MILITARY SPECIFICATION

CABINET, ELECTRICAL EQUIPMENT CY-7887/UPQ-5

This amendment forms a part of Military Specification MIL-C-85441(AS) dated 22 December 1980 and is approved for use by Naval Air Systems command Department of the Navy, and is available for use by all Departments and Agencies of the Department of Defense.

FIG. 1 CABLING DIAGRAM FOR FULL CONFIGURATION

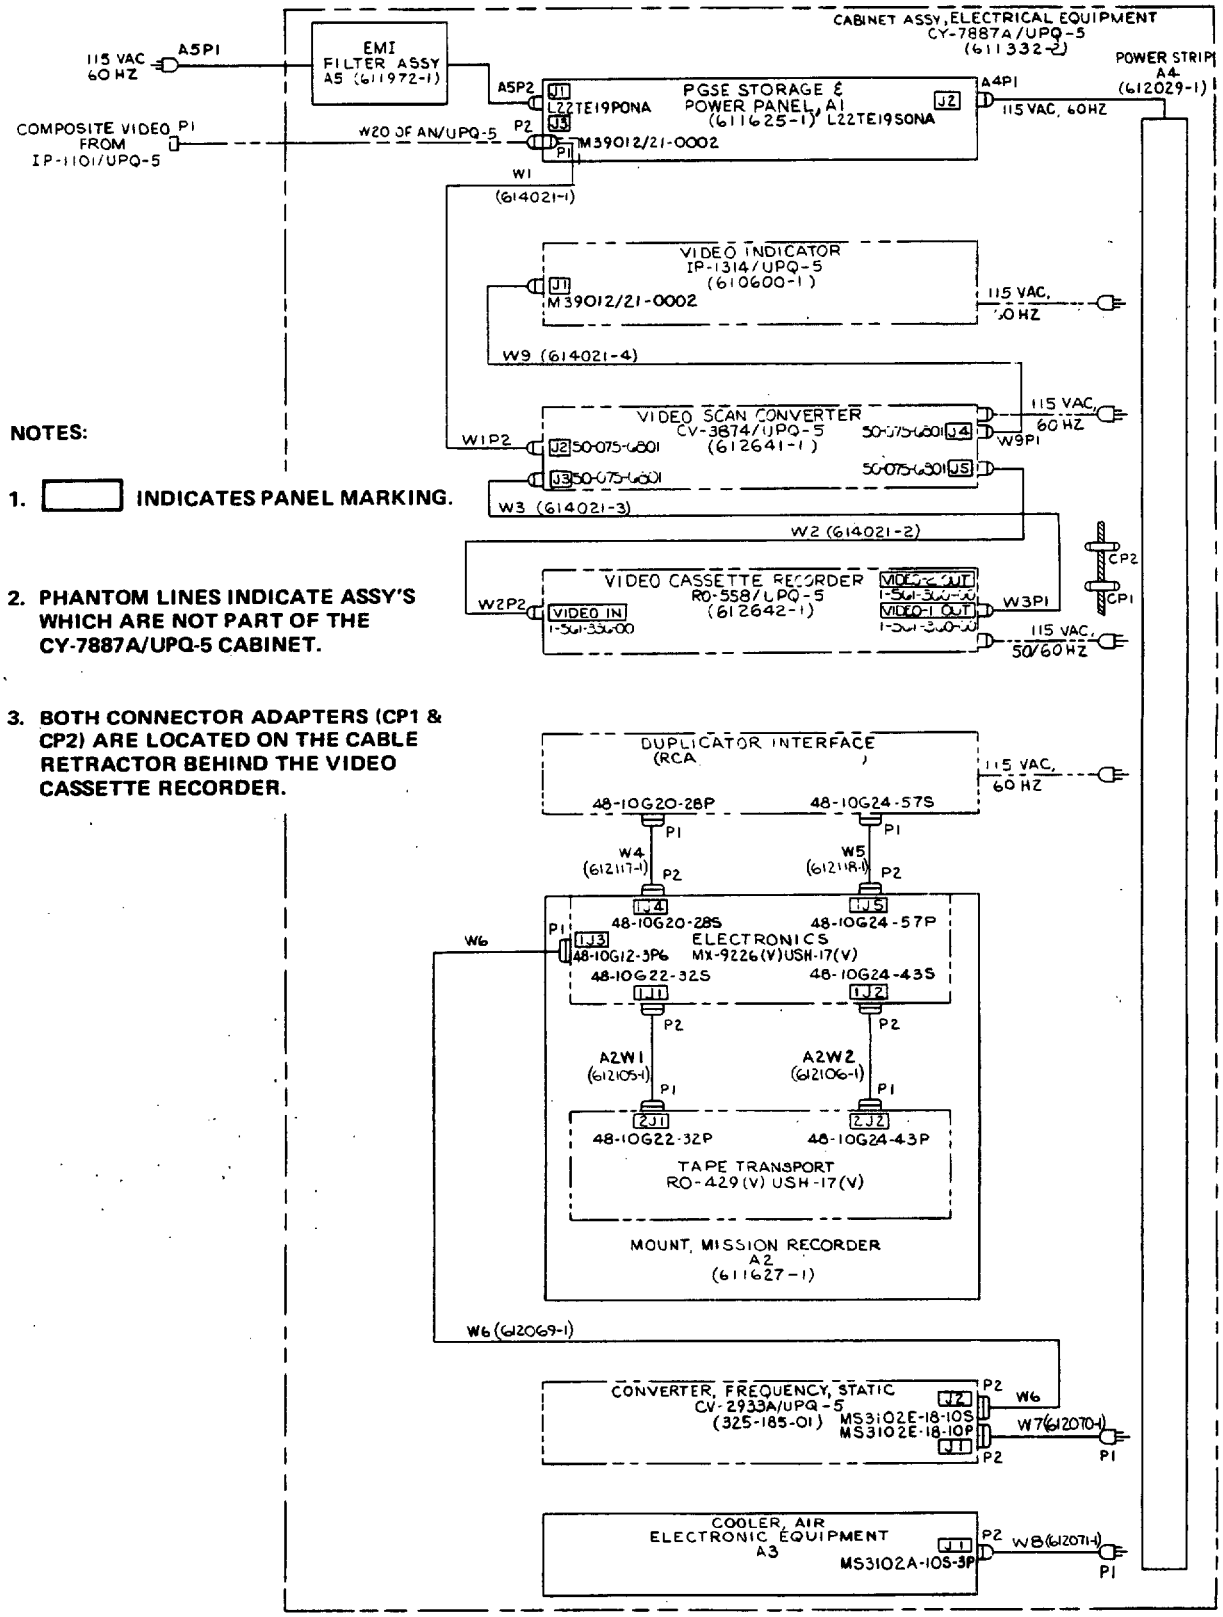
Full configuration signal distribution requirements are illustrated in Figure 1. Full configuration is with both the Video Scan Converter and Video Cassette Recorder installed. Alternate configurations are to by-pass either, or both, of these units using adapters CP1 and CP2."

FIGURE 1: Delete Figure 1 and replace with modified Figure 1 contained herein.
